ATTACHMENT 4

UNIT 2 – AREA WALK-BY CHECKLISTS

NO. SNCV061-RPT-02

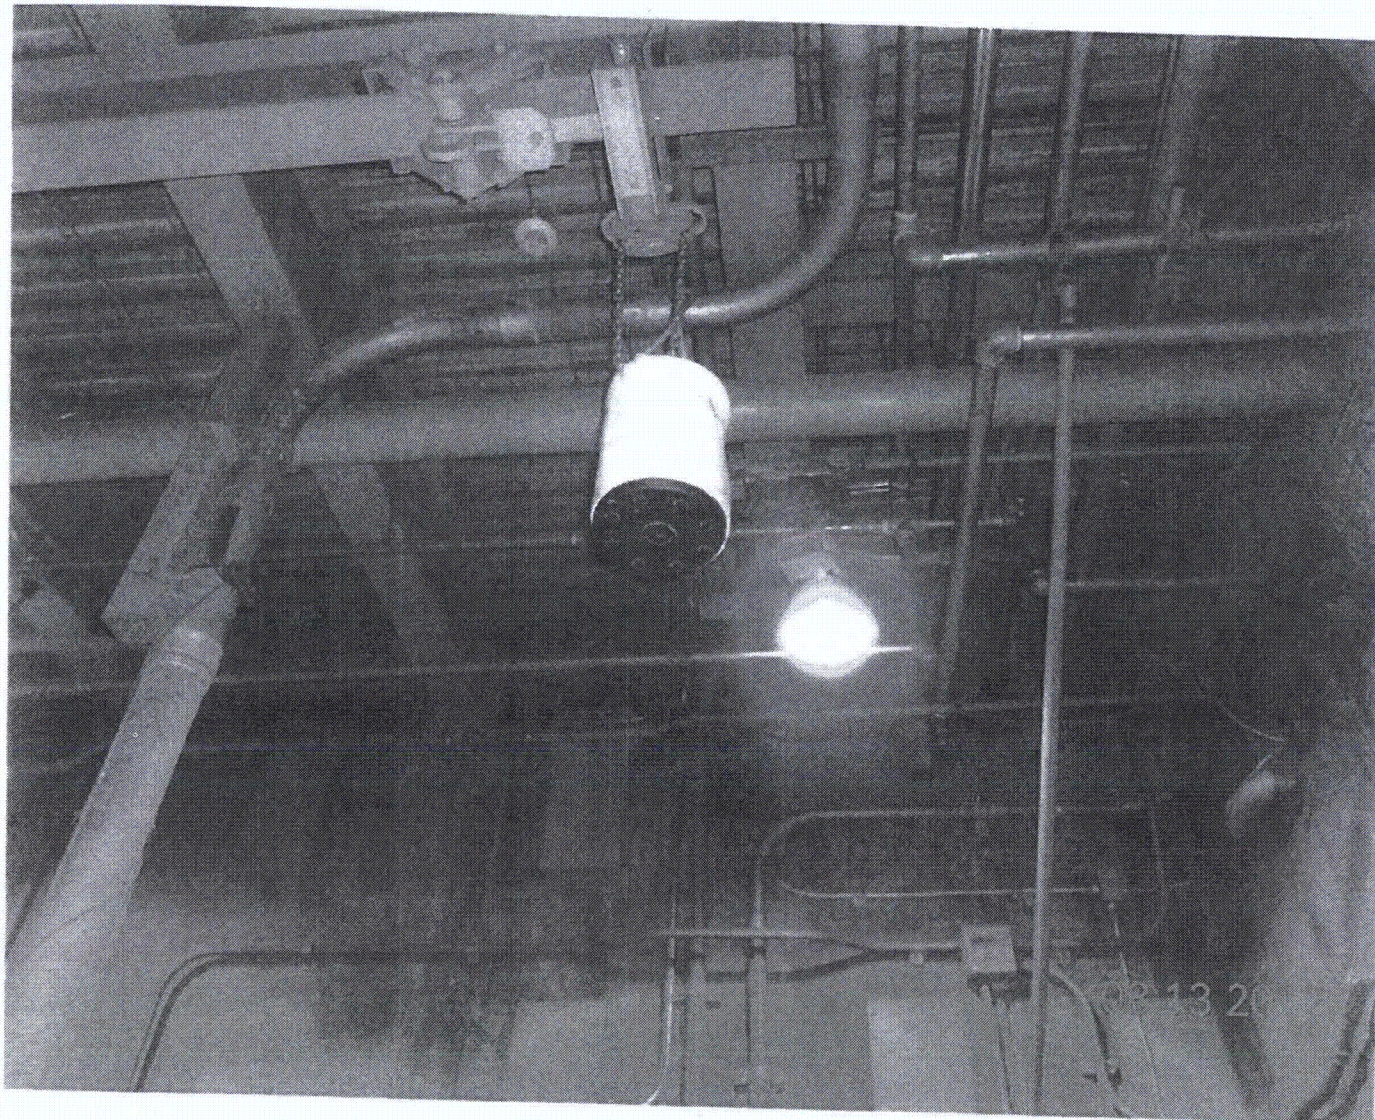
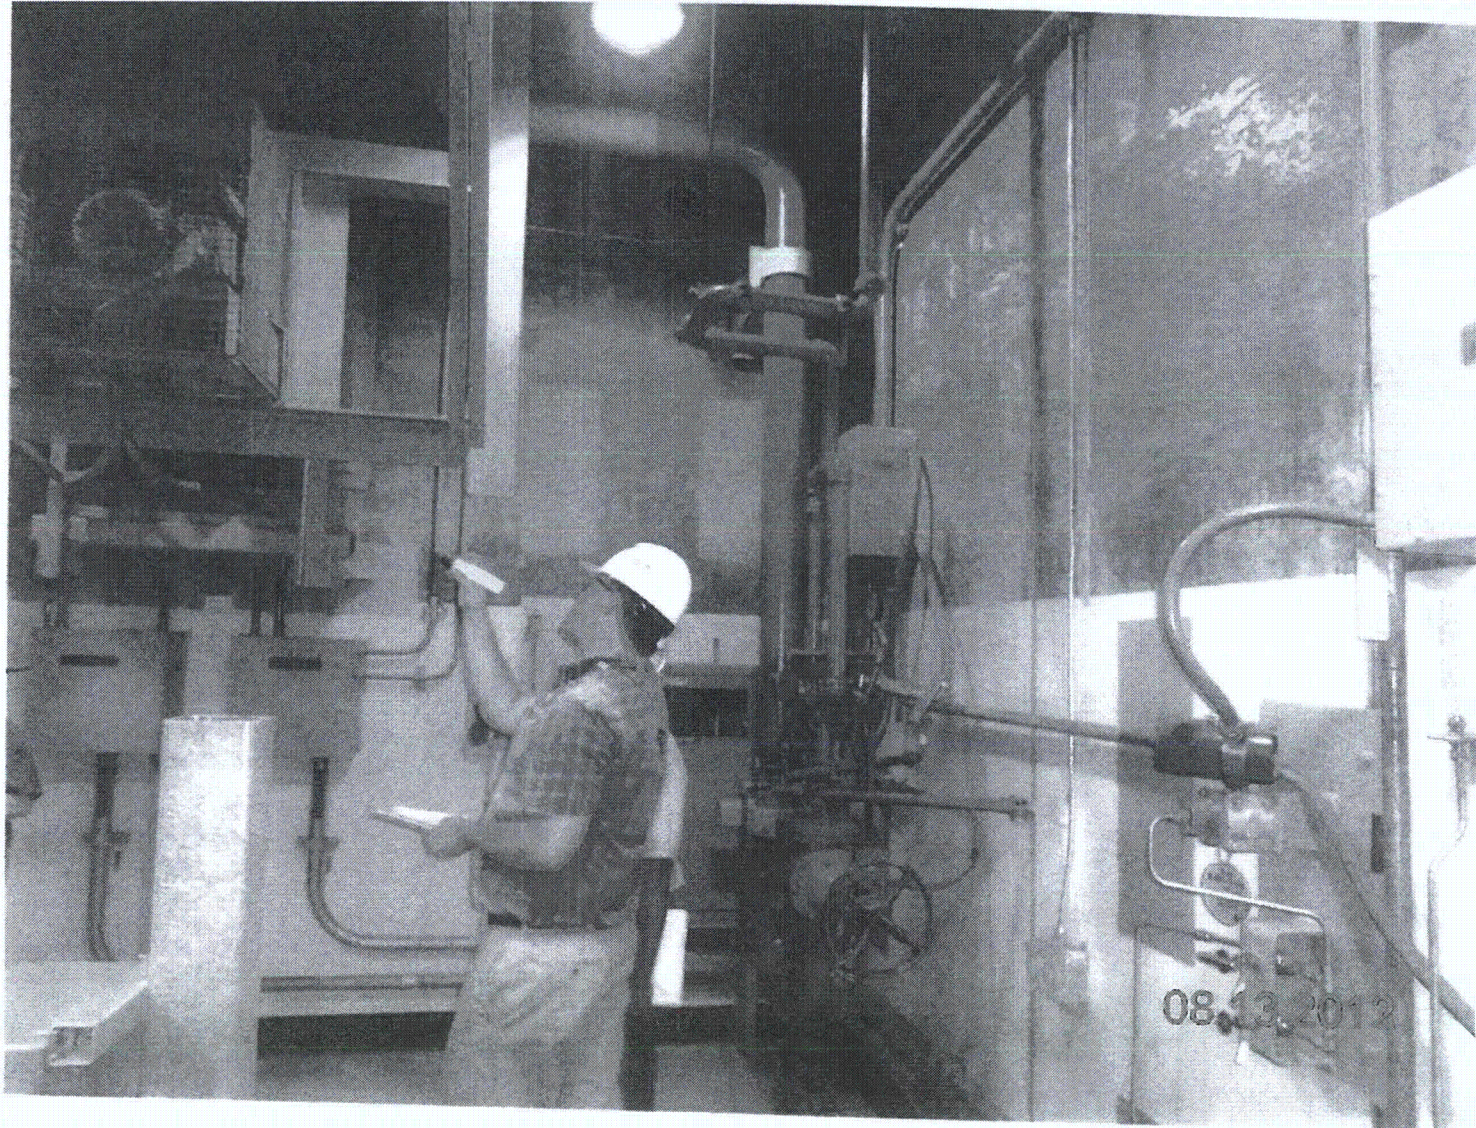
Fire protection pipes below the ceiling have long span & threaded connections. Need evaluation. (See comments for resolution)

Bulbs do not have cages, but if fail, it will not affect the function of equipment.

1) Per Fire protection Engineers John Lattner and Lindy Hughes, and based on Design Criteria DC-2301, this Fire protection piping is dry downstream of actuation valve. Piping upstream of valve is well supported and acceptable. Piping downstream is dry & i. ok

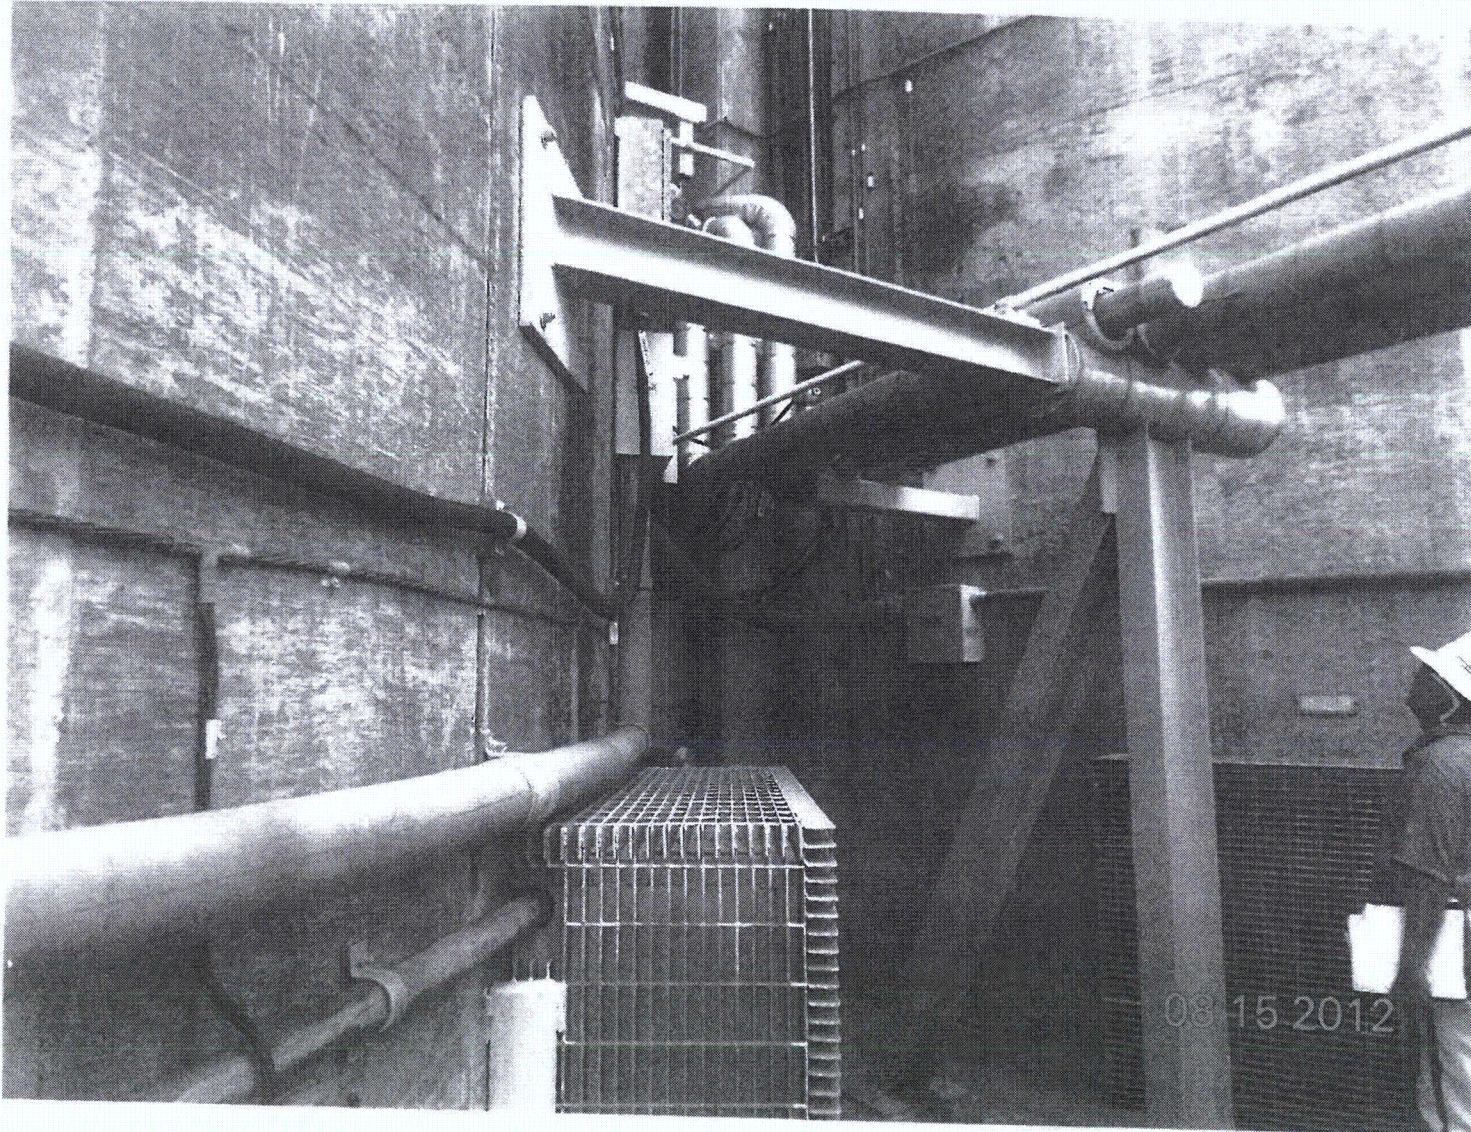
Temporary gas bottle near CST tank #2 are not anchored but acceptable due to the bottles are restrained and structure is not likely to tip over.

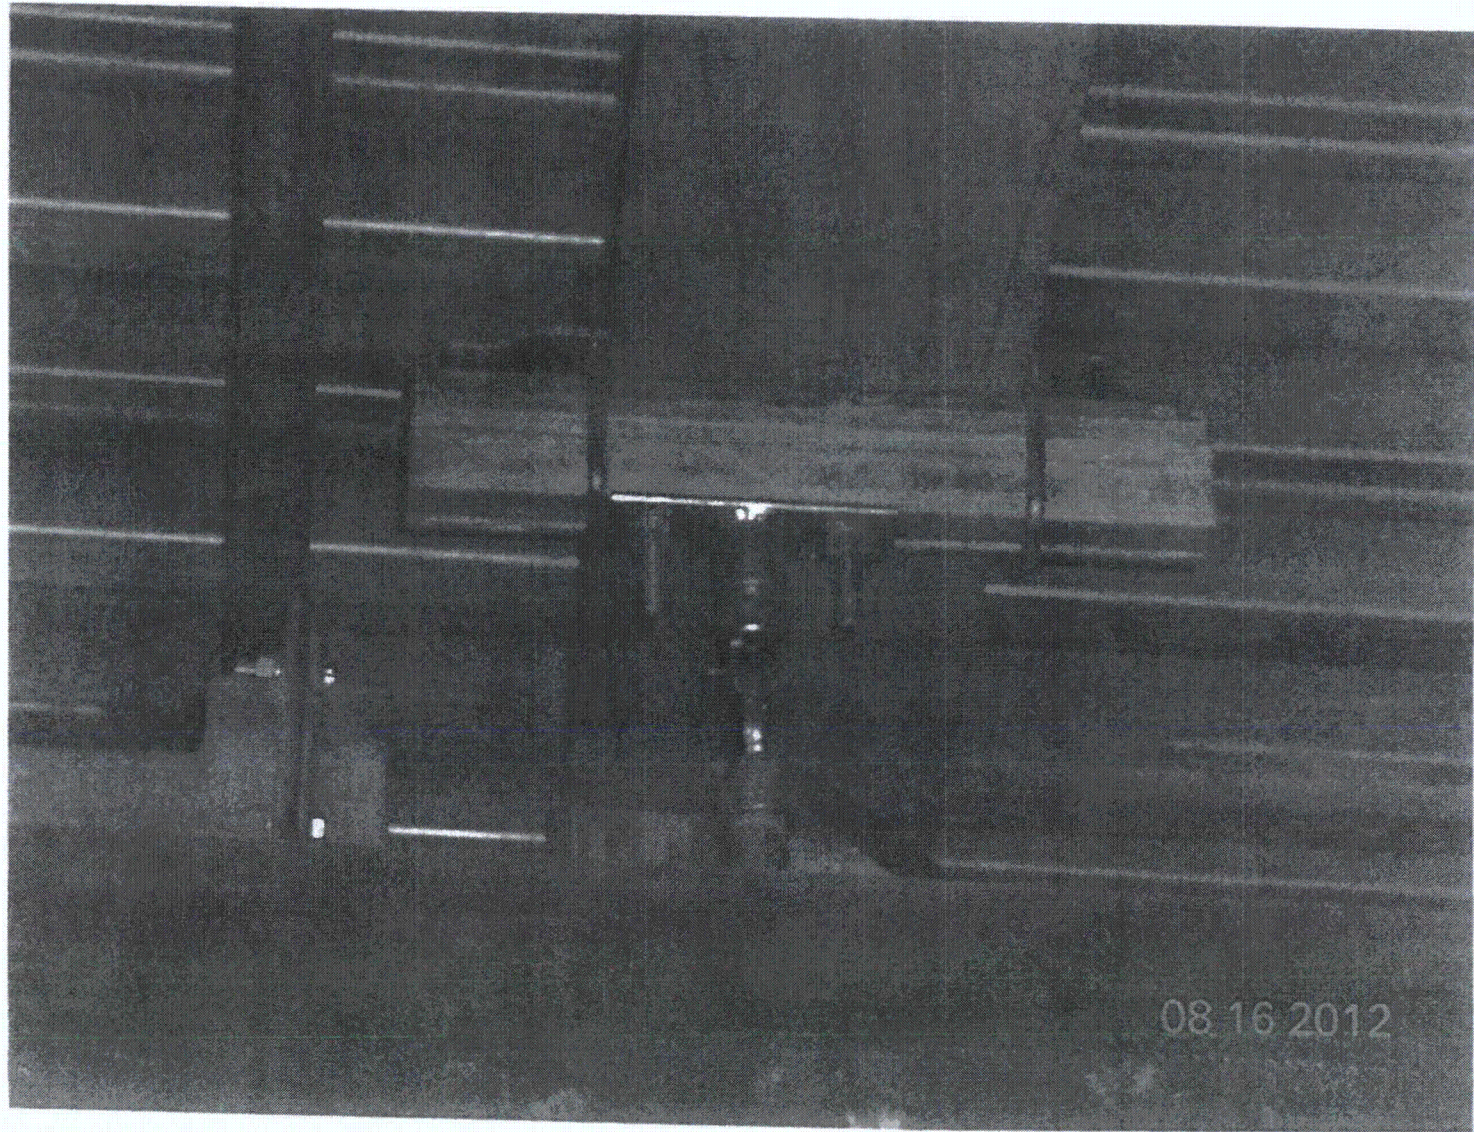
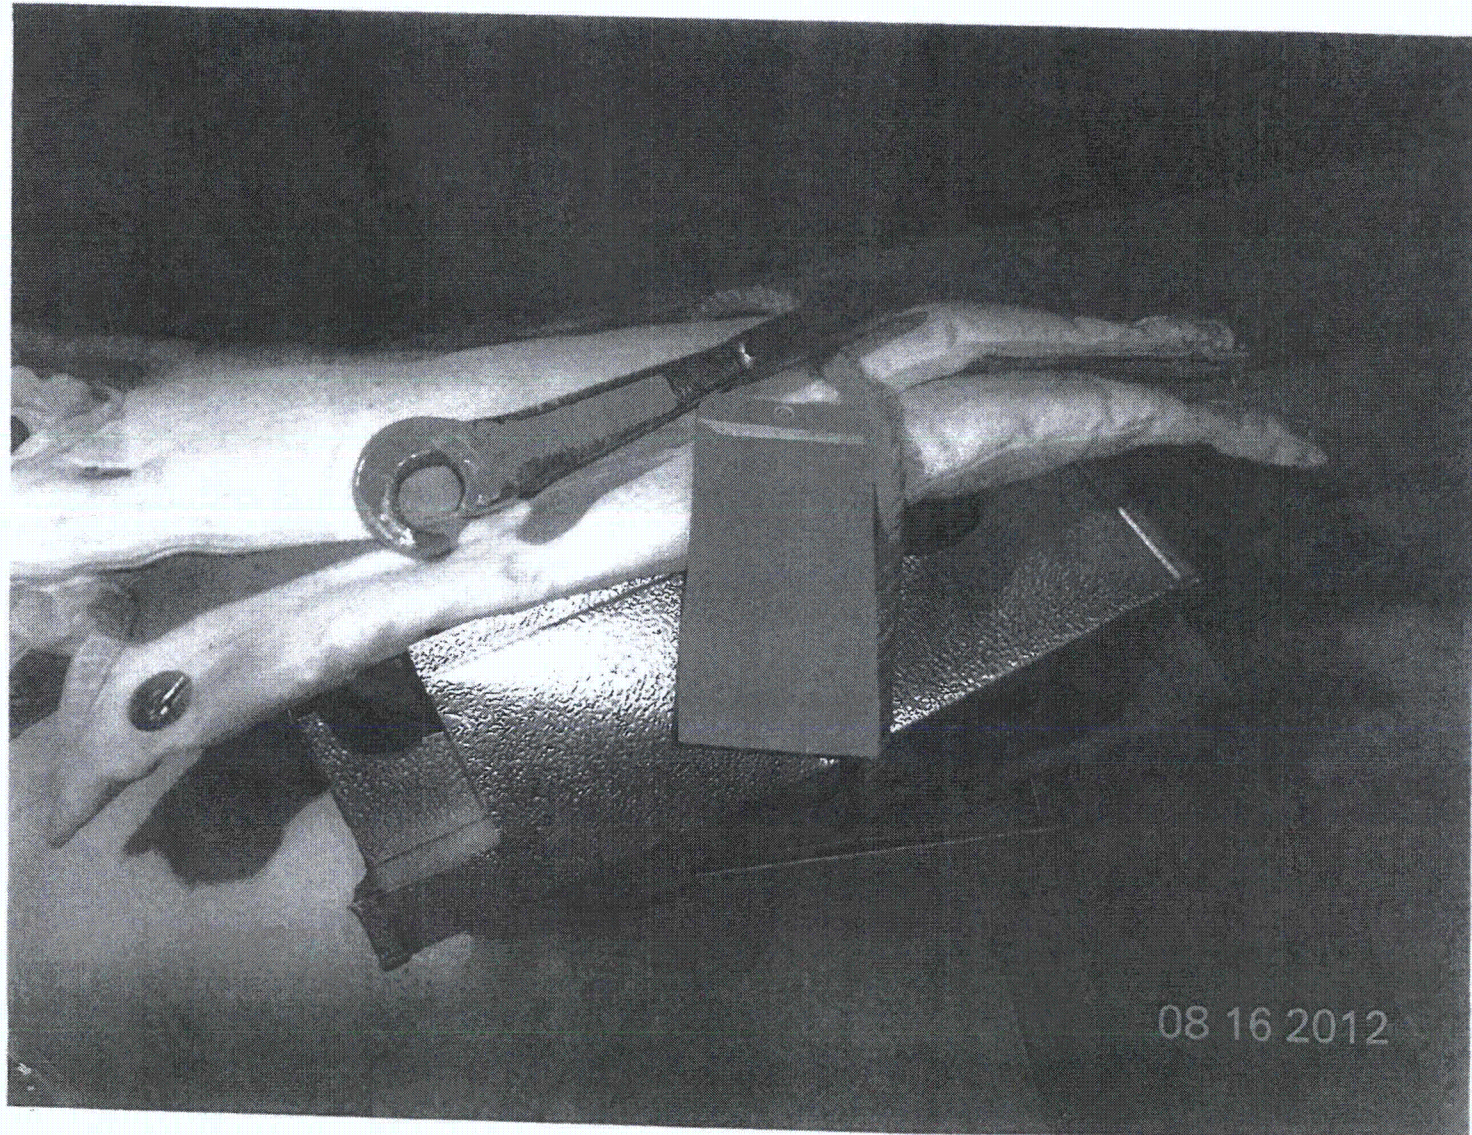
EXIT SIGN CLOSURE SCREW NOT SCREWED IN PROPERLY
 FOLDING CHAIRS STORED BEHIND MEMORY CARTRIDGE
 TRAYS NOT SEISMIC COLLARED SINCE THEY ARE NOT IN
 CLOSE PROXIMITY TO ANY SAFETY RELATED EQUIPMENT

SEE CR# 504324 & 504853
